Access Compliance Report

Public Rights-of-Way

(Curb Ramps)

Intersection ID: 10036962	Main Street: S_TRYON_ST	Cross Street: N/A	Location: NE
ADA ID: A2EC491C5EA3	Ramp Type: Perp	Initial Pass/Fail: Fail	Overall Compliance: No
Severity Score: 35			
Codes/Mitigation Info/Possible Solution		Field Measurements/Component Compliance

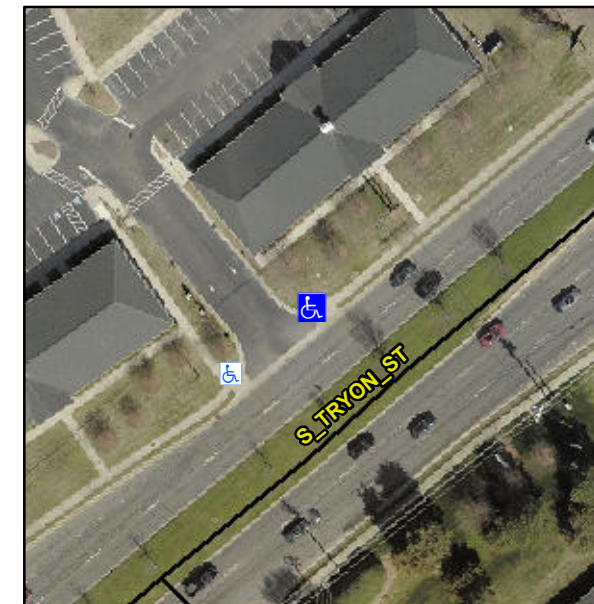
Not Found, R304.5.1, R304.2.2, R304.5.3

Compliance	Description	Data	Compliance	Description	Data
N/A	Ramp Length (in)	29.0	No	Ramp Slope (%)	12.1
No	Ramp Width (in)	46.0	No	Ramp XSlope (%)	4.1
N/A	Flare Type LT	N/A	N/A	Flare Type RT	N/A
N/A	Flare Slope LT (%)	N/A	N/A	Flare Slope RT (%)	N/A
N/A	Flare Traversable LT?	N/A	N/A	Flare Traversable RT?	N/A
N/A	Landing Length (in)	N/A	N/A	DWS Provided?	N/A
N/A	Landing Width (in)	N/A	N/A	DWS Contrast?	N/A
N/A	Landing Slope (%)	N/A	N/A	DWS Length (in)	N/A
N/A	Landing X Slope (%)	N/A	N/A	DWS Full Width?	N/A
N/A	Landing Curb? (Y/N)	N/A	N/A	DWS Offset (in)	N/A
N/A	Shared Landing?	N/A			
N/A	Gutter Ponding?	N/A	N/A	Gutter Slope (%)	N/A
N/A	Gutter Lip Ht (in)	N/A	N/A	Gutter X Slope (%)	N/A
N/A	Painted X Walk1?	No	N/A	Painted X Walk2?	N/A
	X Walk 1 Direction	To W		X Walk 2 Direction	N/A
N/A	X Walk 1 Width (in)	N/A	N/A	X Walk 2 Width (in)	N/A
	X Walk 1 Slope (%)	1.5		X Walk 2 Slope (%)	N/A
	X Walk 1 X Slope (%)	5.6		X Walk 2 X Slope (%)	N/A

Remove & Replace Entire Ramp.
